Addendum 2

Project Stadium New Press Box – Marlin ISD
Issued December 8, 2023 by CEI Engineering Associates, Inc.
Proposal Opening December 14th at 2:00 PM

ADDENDUM NO. 2

PROJECT: Marlin ISD - Pressbox
HKS Project No. 26095.000

01 NORTH ELEVATION

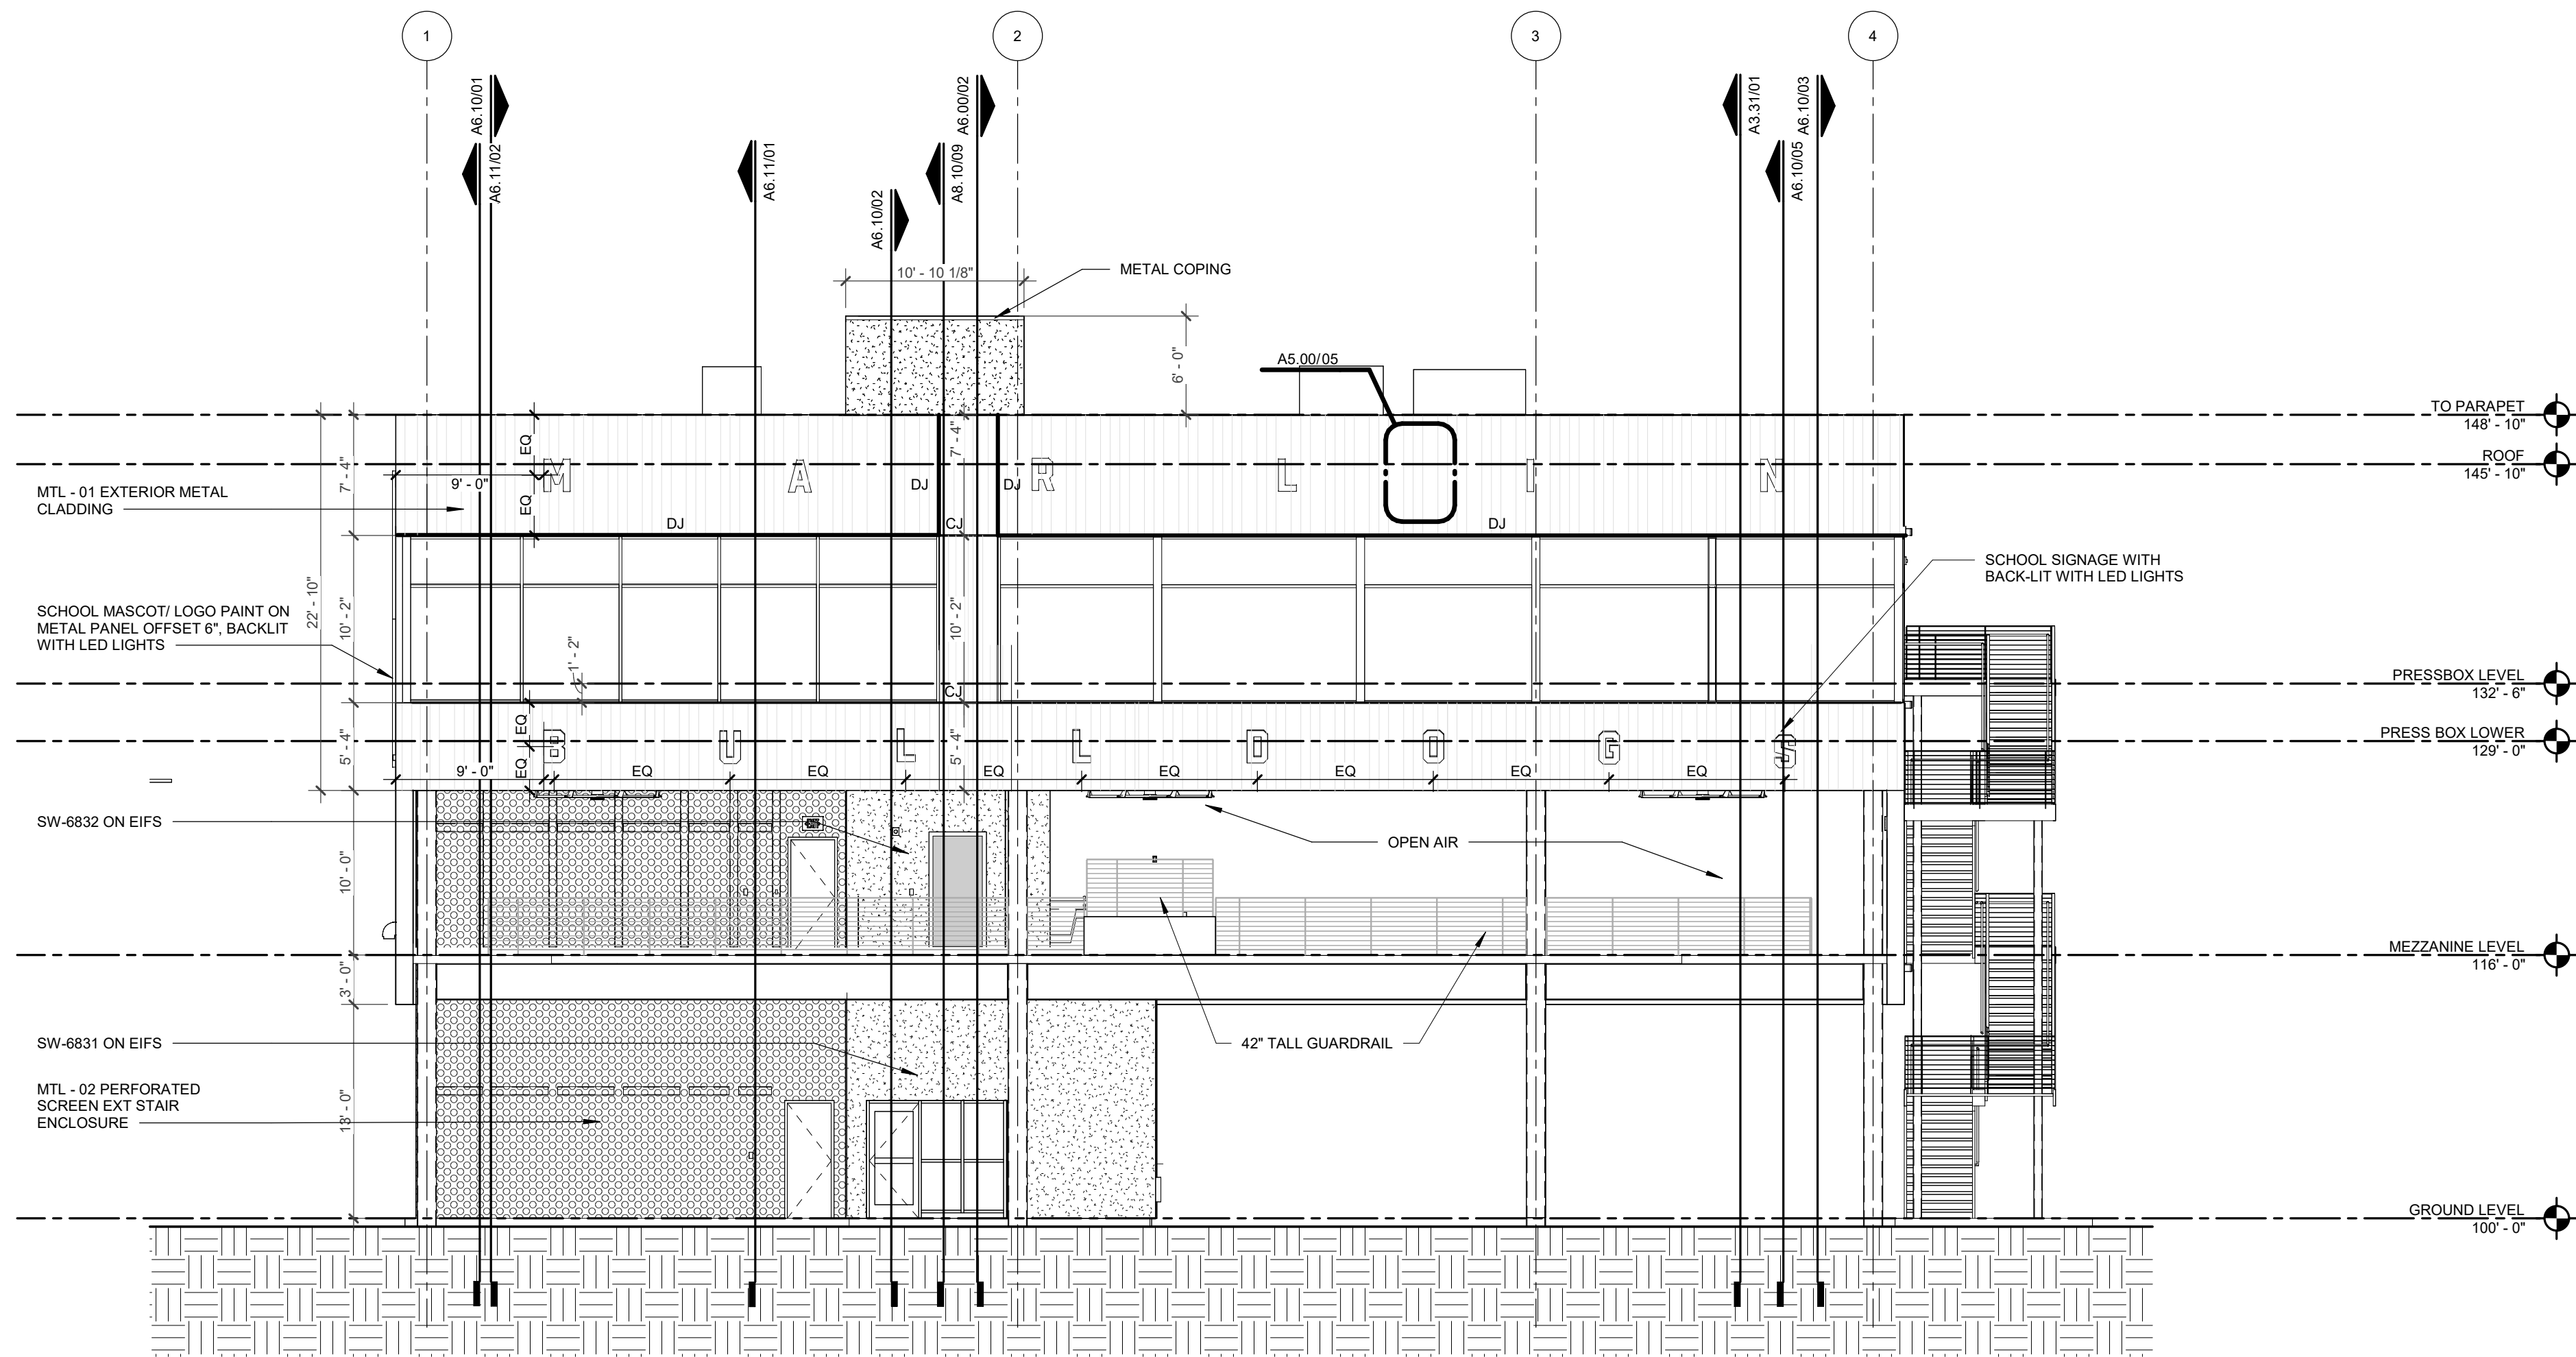
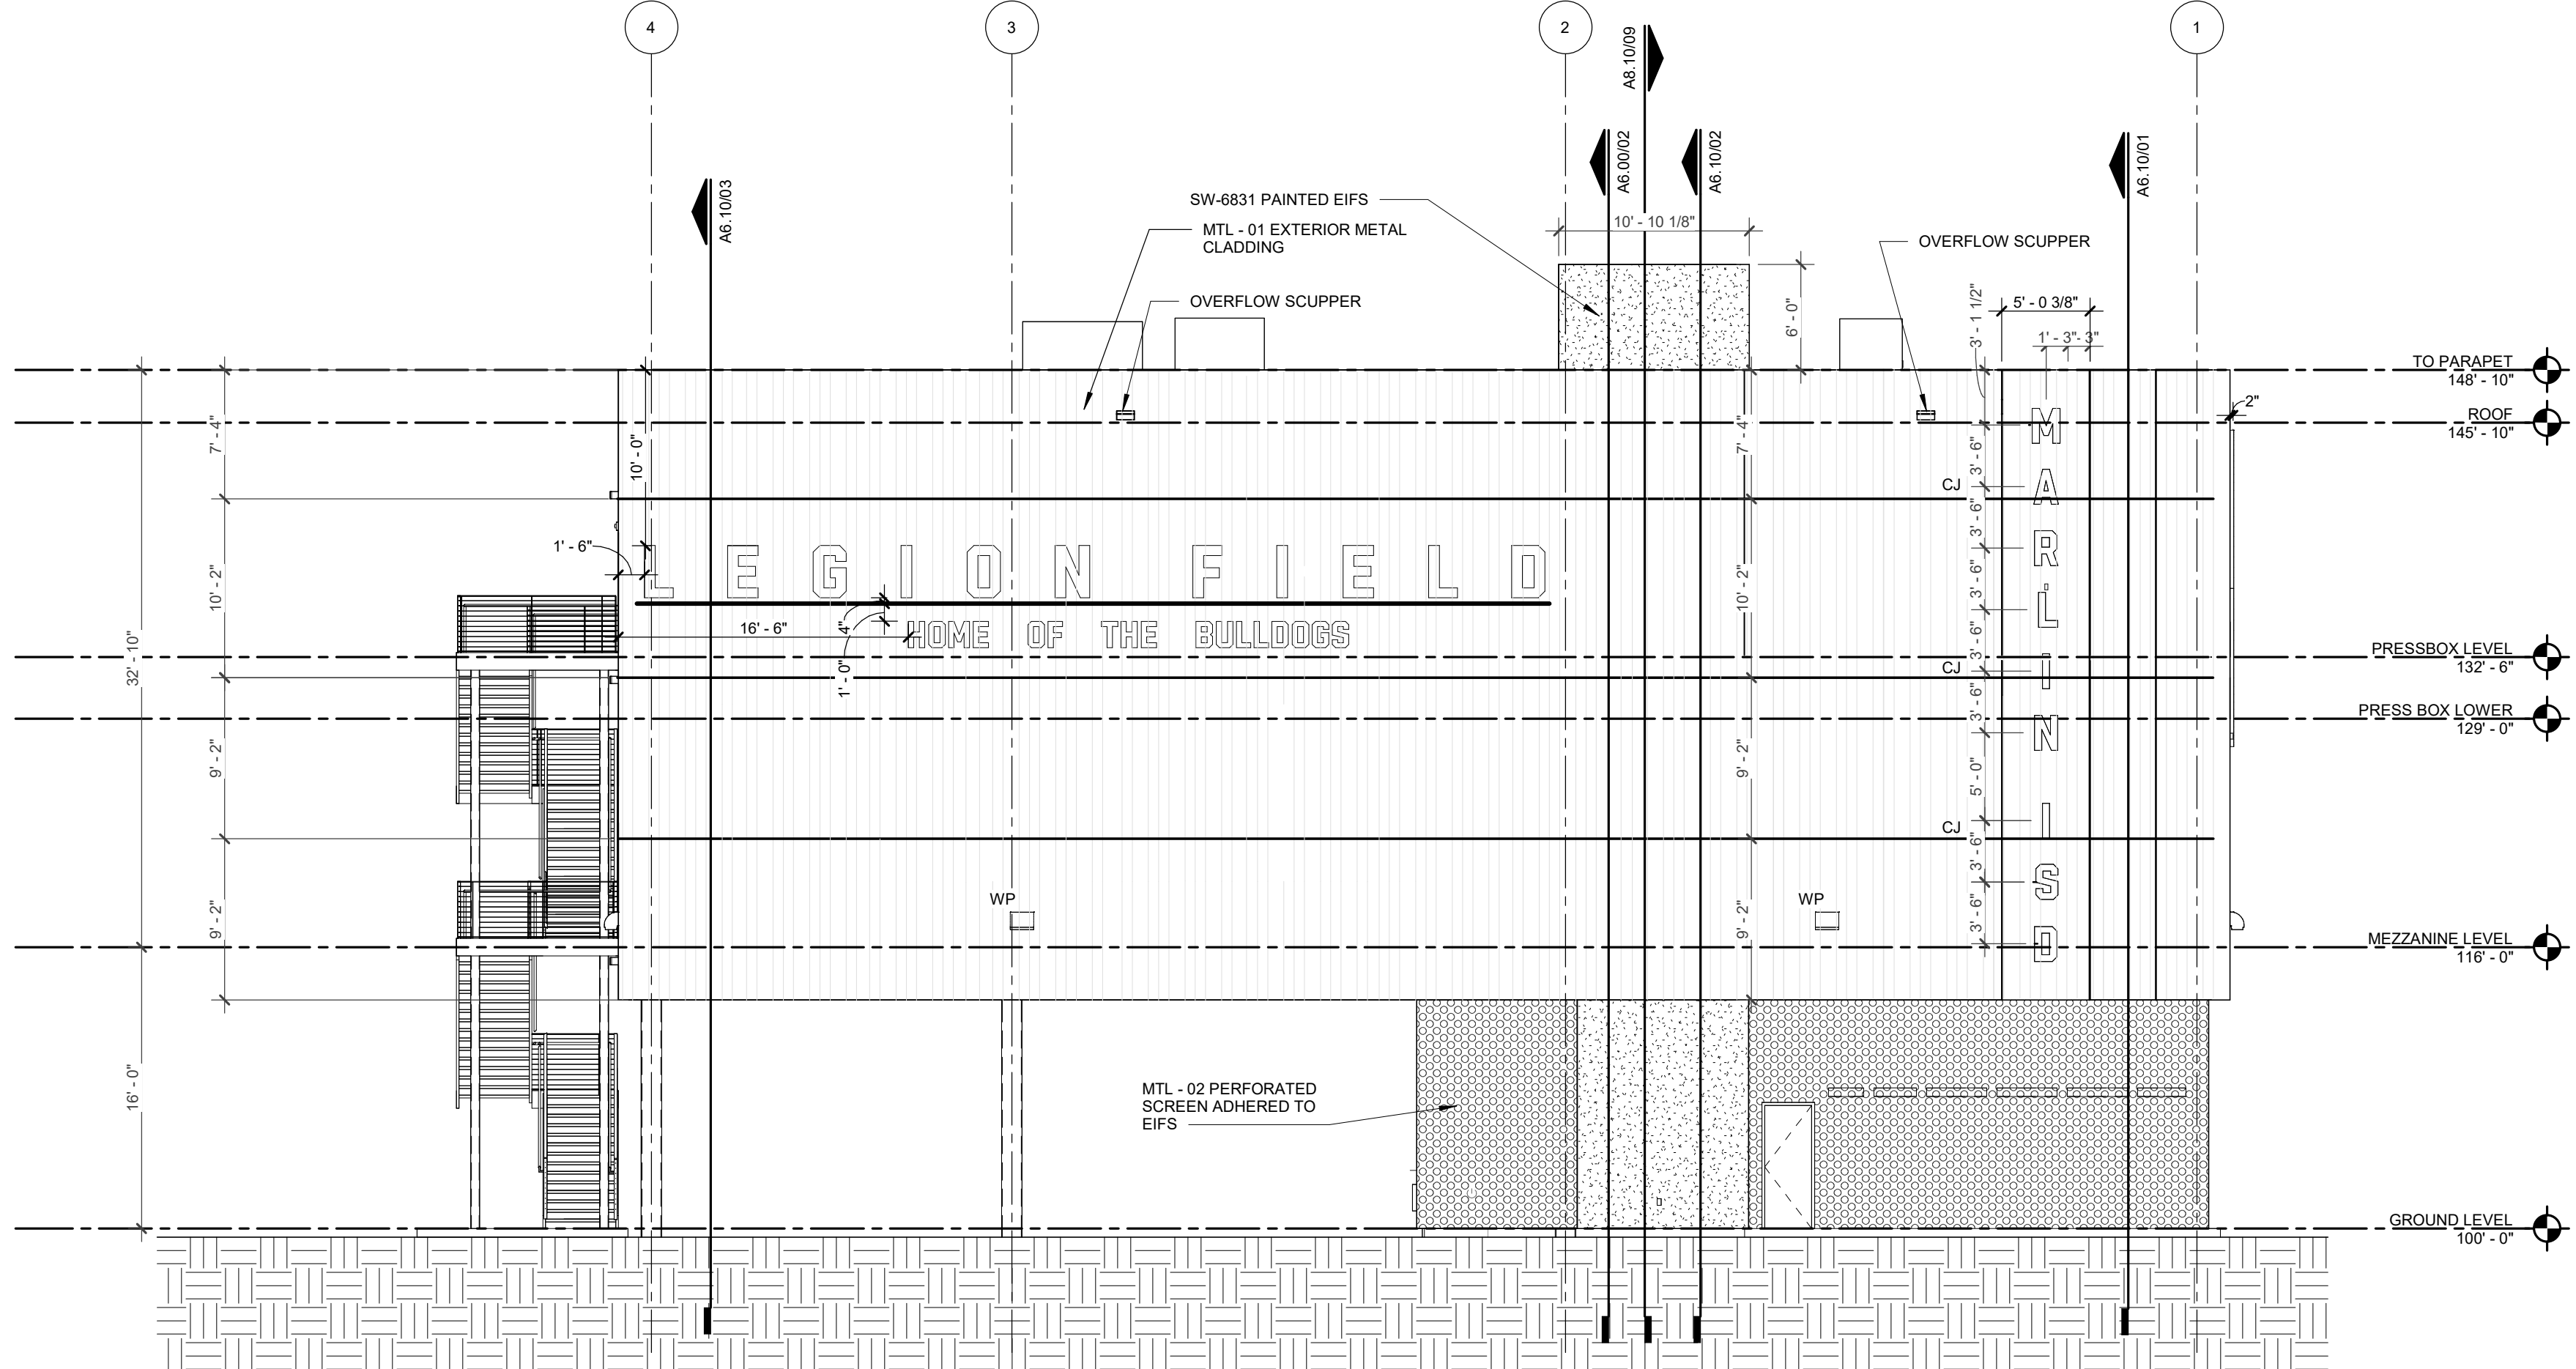
- **A5.00 – EXTERIOR ELEVATIONS**
 - Added "LEGION FIELD" signage to North Elevation
 - Updated height of exterior window at East Elevation
 - Updated signage to South Elevation

-Added Bulldog logo for reference to West Elevation

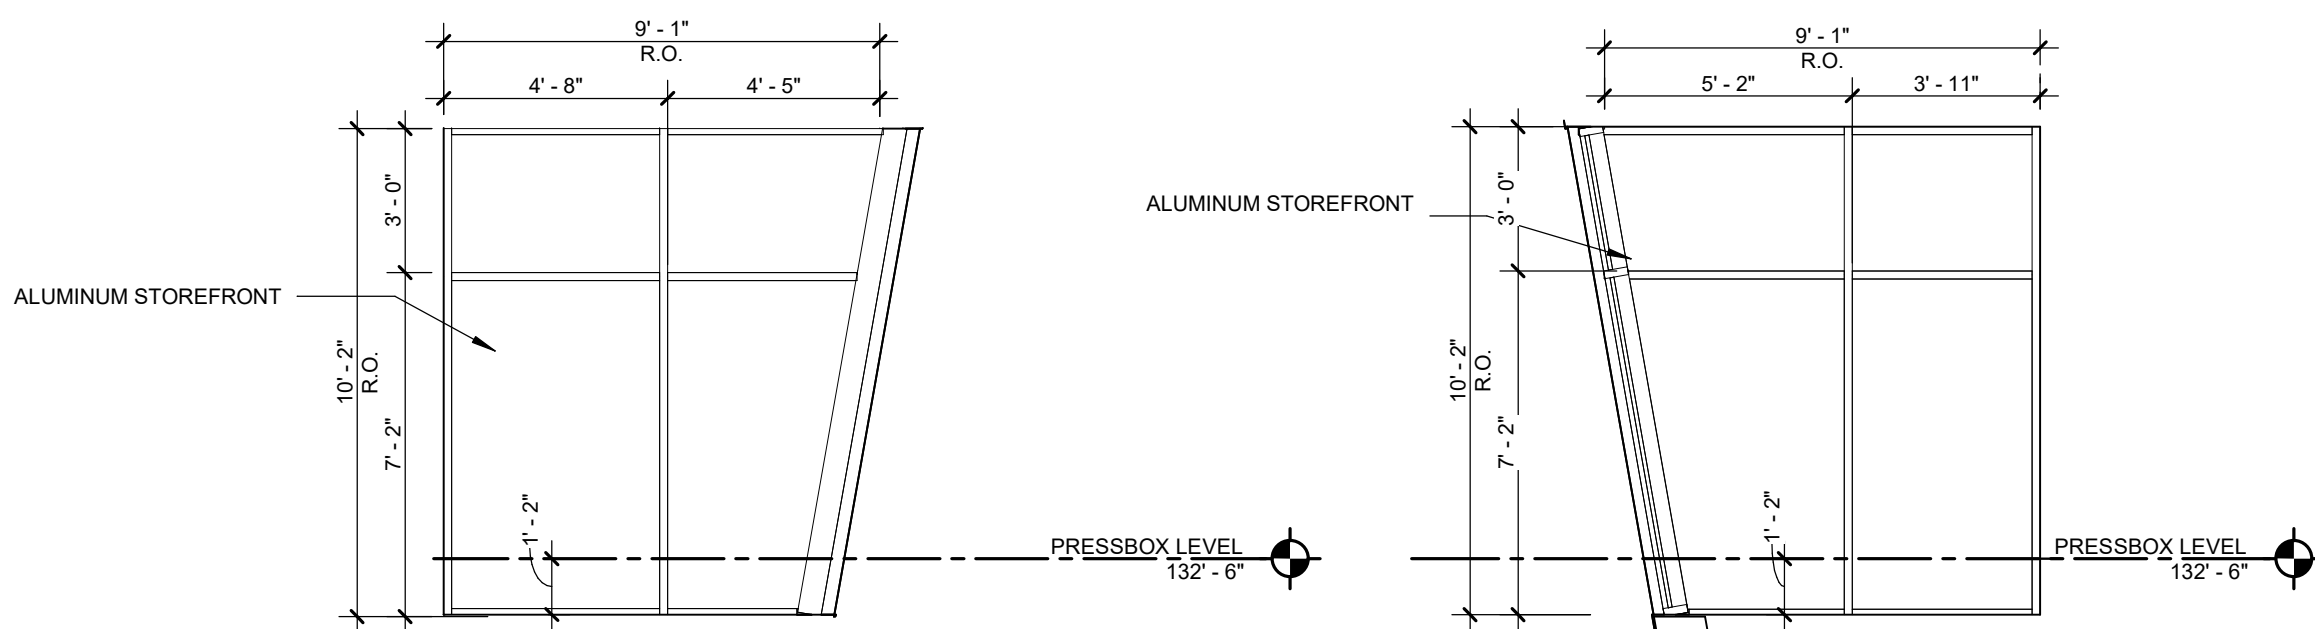
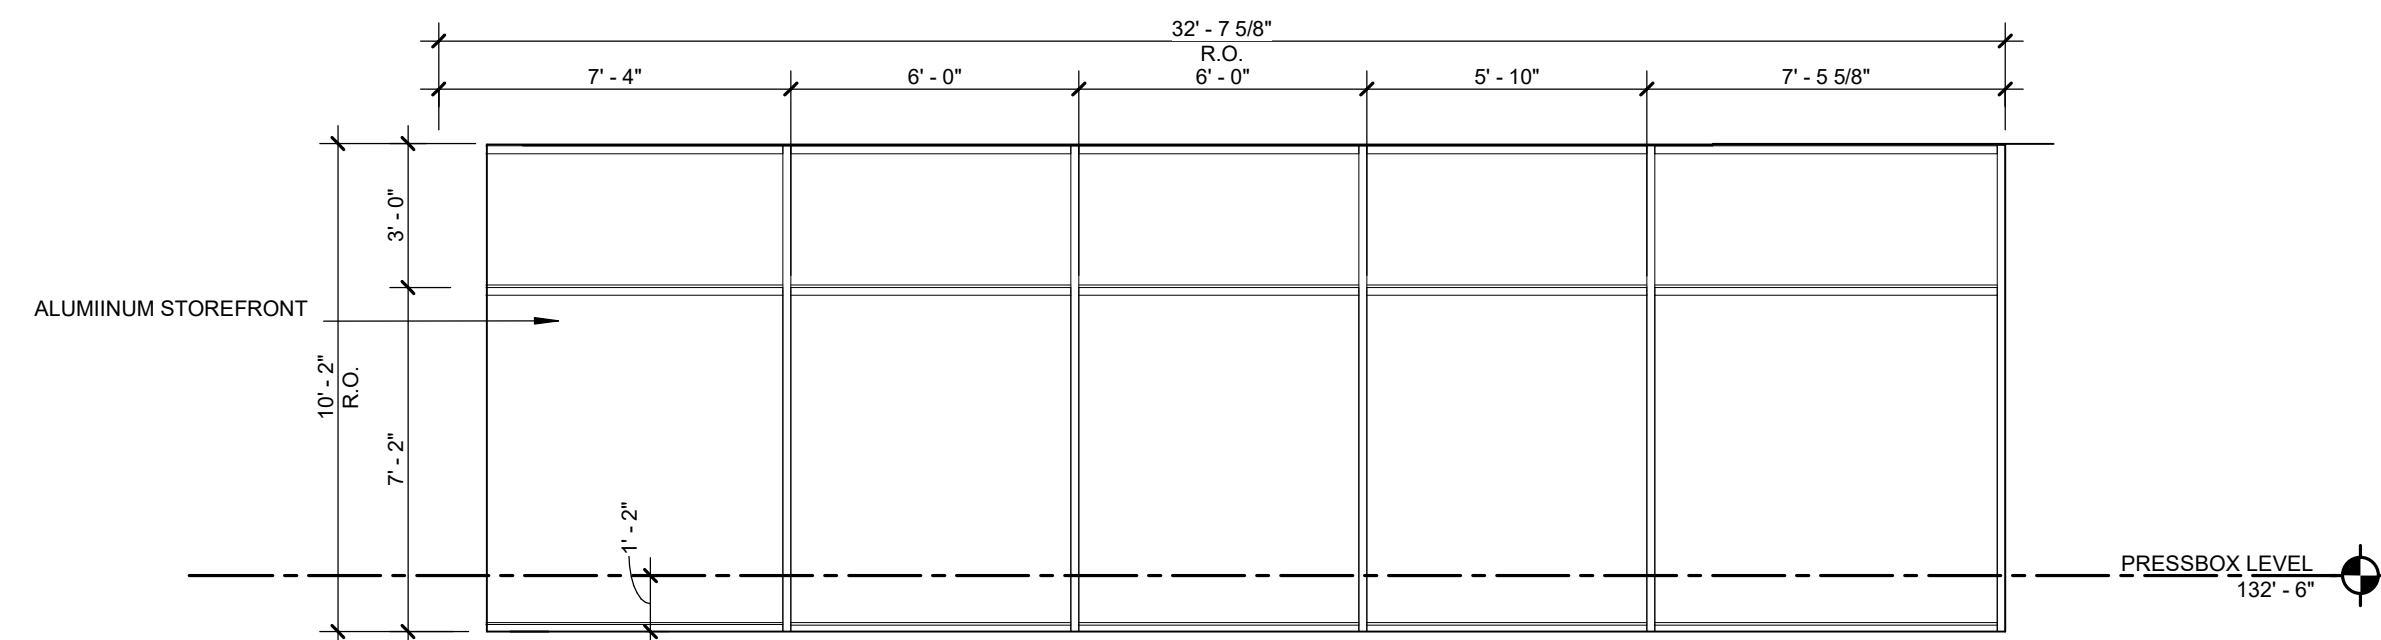
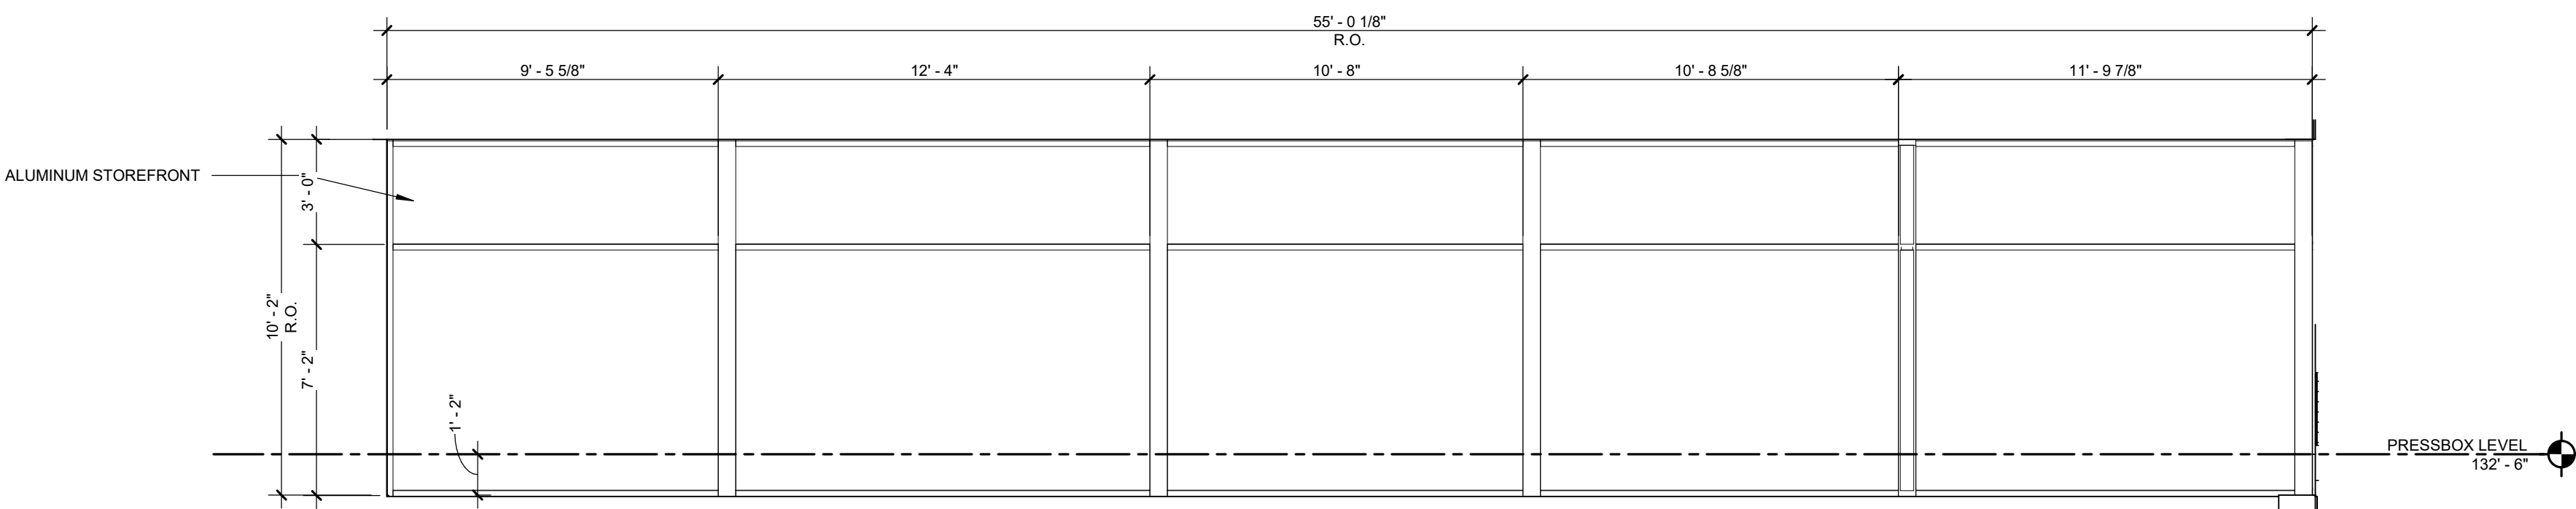
- **A5.10 – WINDOW ELEVATIONS**
 - Updated height of window at South Elevation Pressbox
 - Updated height of East Elevation window
- **A6.10 – WALL SECTIONS**
 - Changed view extents to show interior wall at stairwell
 - Added Section 02 for elevator shaft
- **A6.11 – WALL SECTIONS**
 - Added additional information to Section 07
- **A7.10 – METAL PANEL DETAILS 01**
 - Added details 09,10, and 11
- **A7.11 – METAL PANEL DETAILS 02**
 - Added detail 04
- **A8.00 – STEEL STAIR PLANS AND SECTIONS**
 - Updated Stair plans 01 and 02 to show structural columns
- **A8.10 – ELEVATOR PLAN AND DETAILS**
 - Updated Views 09 and 13
